DEVELOPMENT REVIEW BOARD MEETING

2. **Resolution No. 420. Charbonneau Country Club Tennis Building.** The applicant is requesting approval of a Stage 2 Final Plan and Site Design Review for the addition of a steel frame building over the existing outdoor tennis courts at Charbonneau Country Club.

**DEVELOPMENT REVIEW BOARD  
RESOLUTION NO. 420**

Exhibit A1  
Staff Report  
Wilsonville Planning Division  
Charbonneau Tennis Court Building  
Development Review Board Panel 'B'  
Quasi-Judicial Public Hearing

**FIRE SERVICE PLAN**

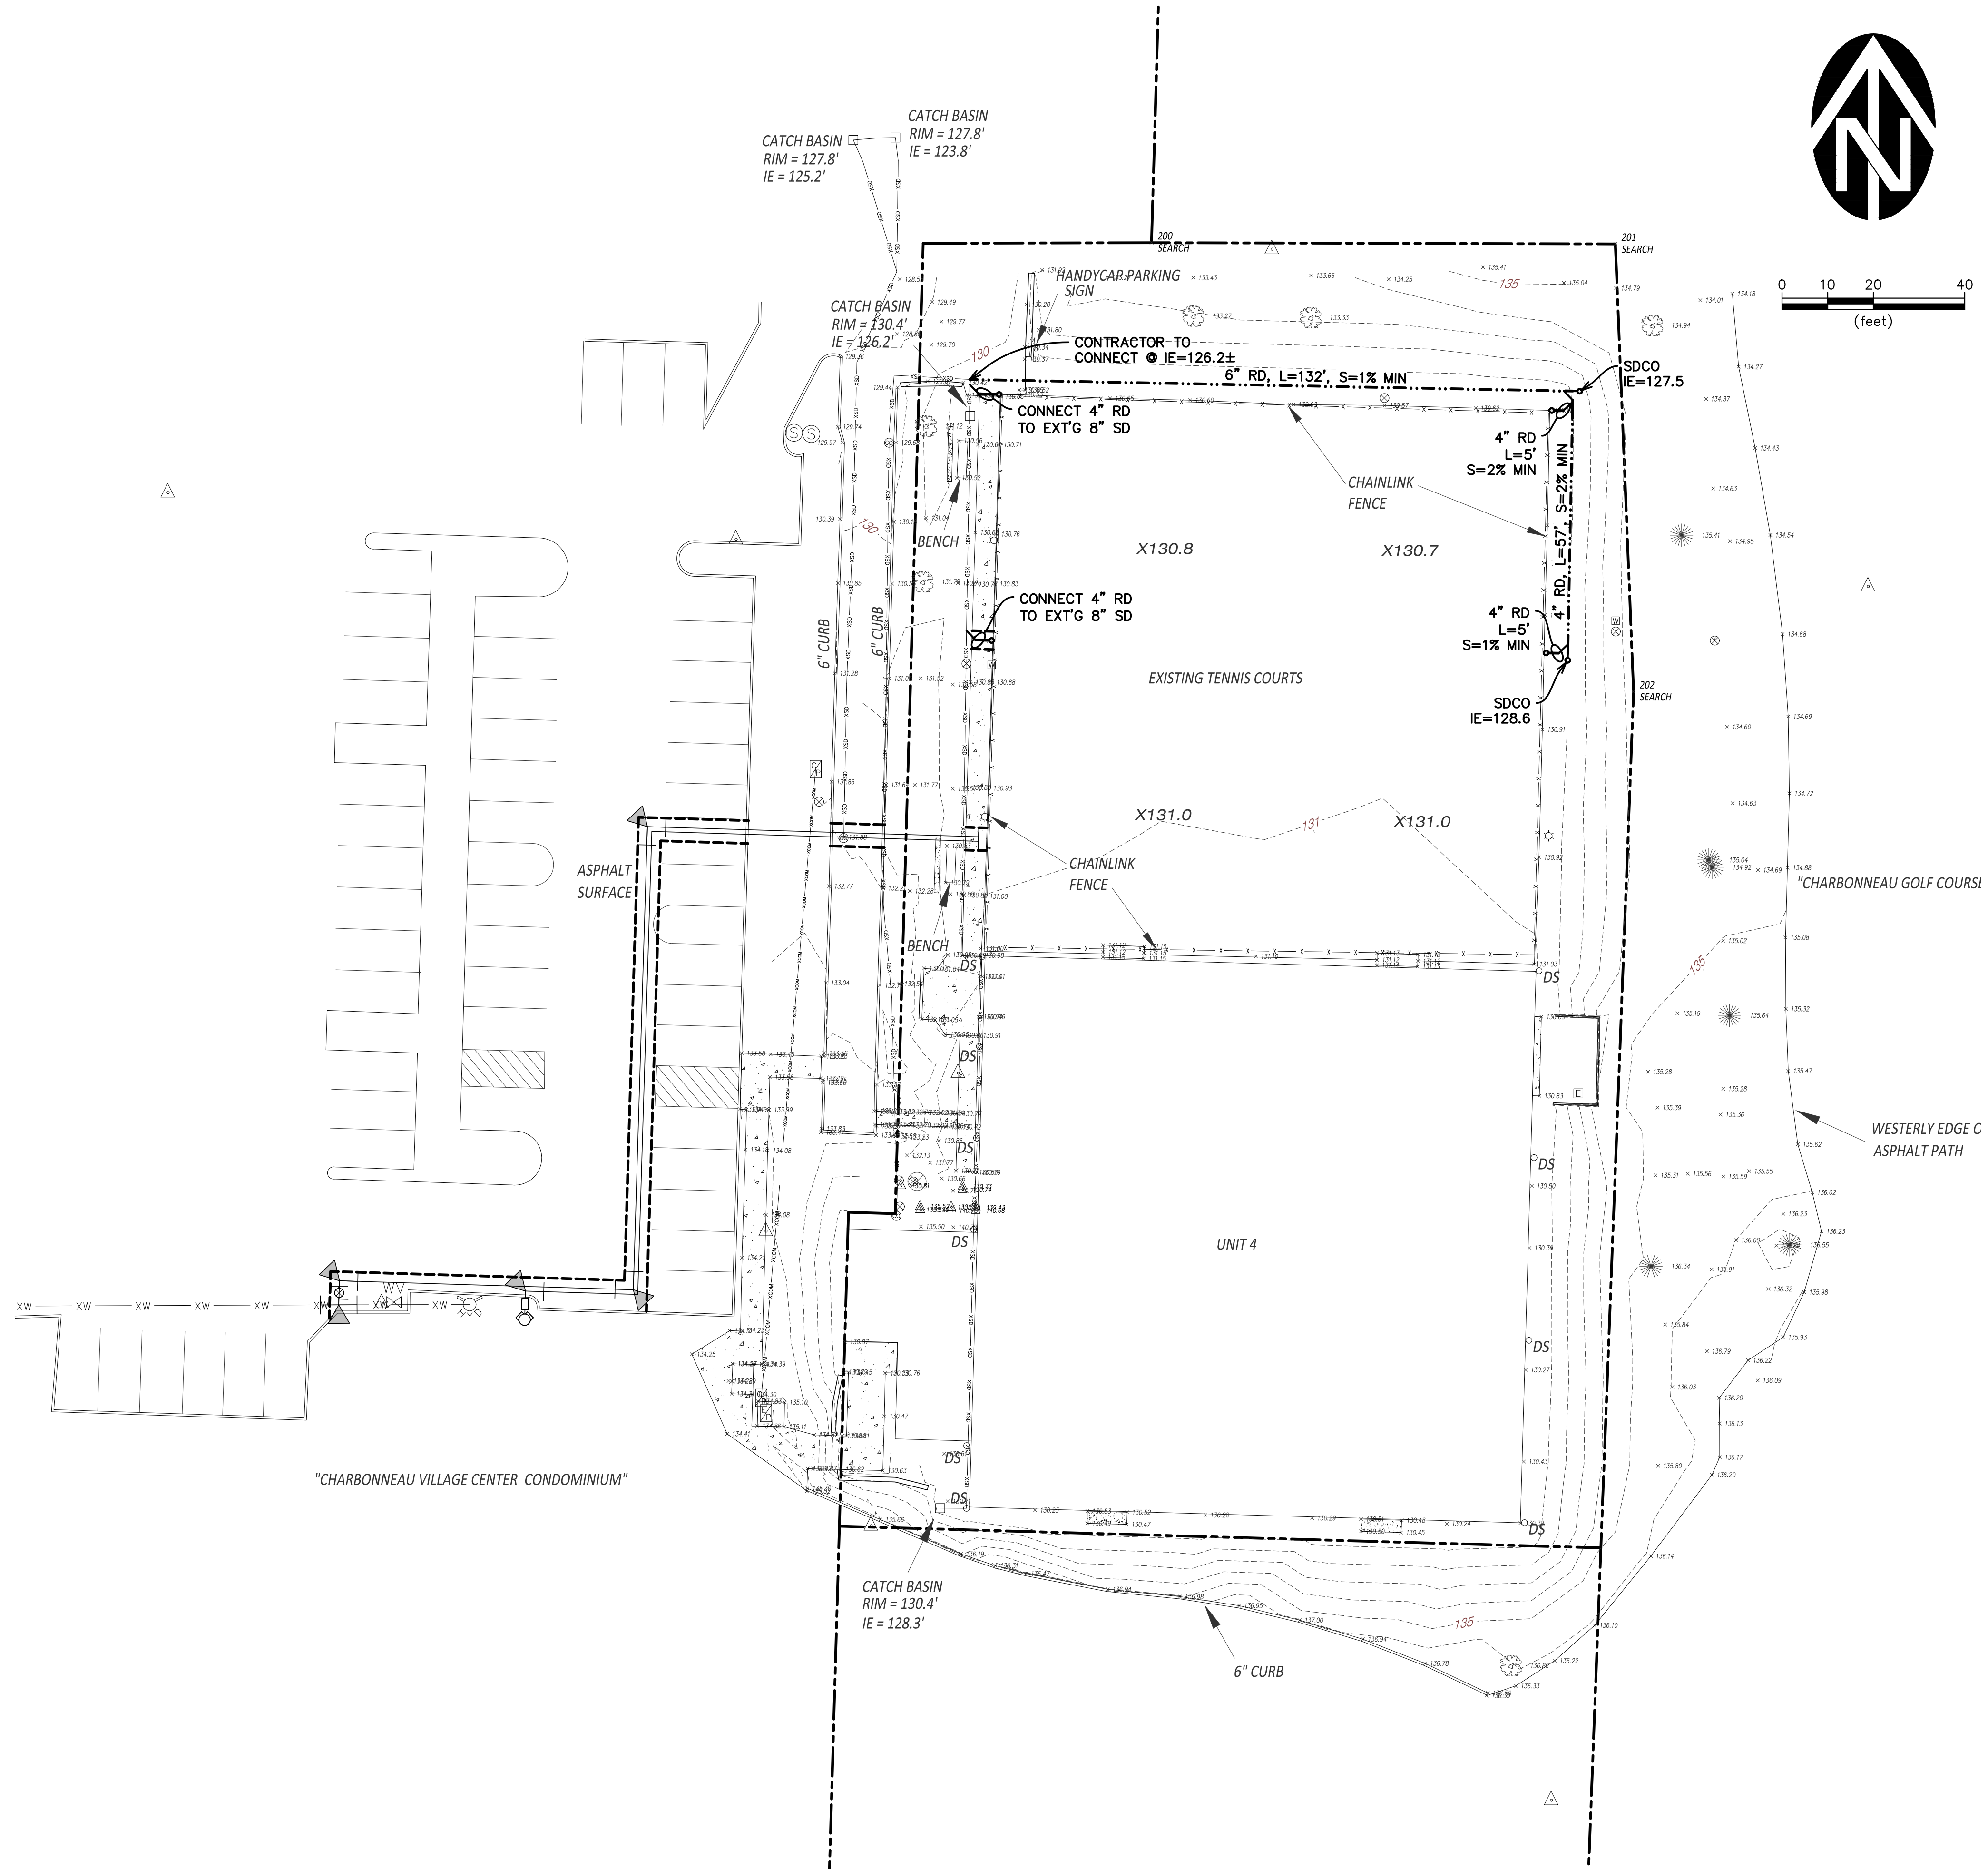
<p><b>PF 4.</b> <u><b>Prior to the Issuance of the Public Works Permit:</b></u> A site plan shall be submitted showing the proposed connection to the public water main for the new fire service connection.</p>
